Brookline Design Advisory Team Meeting

July 16th 2014

Design revisions made since the DPIR submission March 2013

375-399 Chestnut Hill Avenue Boston/Brookline, MA

Previously Proposed Elevation on MBTA Easement

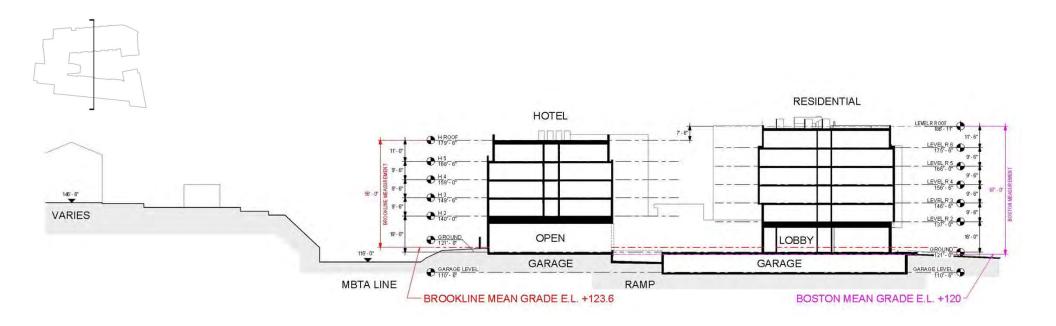
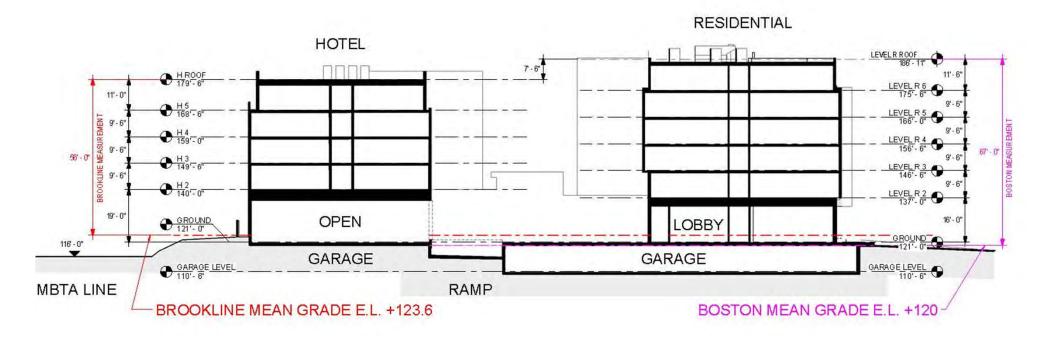
- Redesigned the project for a more traditional design aesthetic.
- Increased the amount of brick, added bay windows and symmetry
- Created a clear base, middle & top to the building
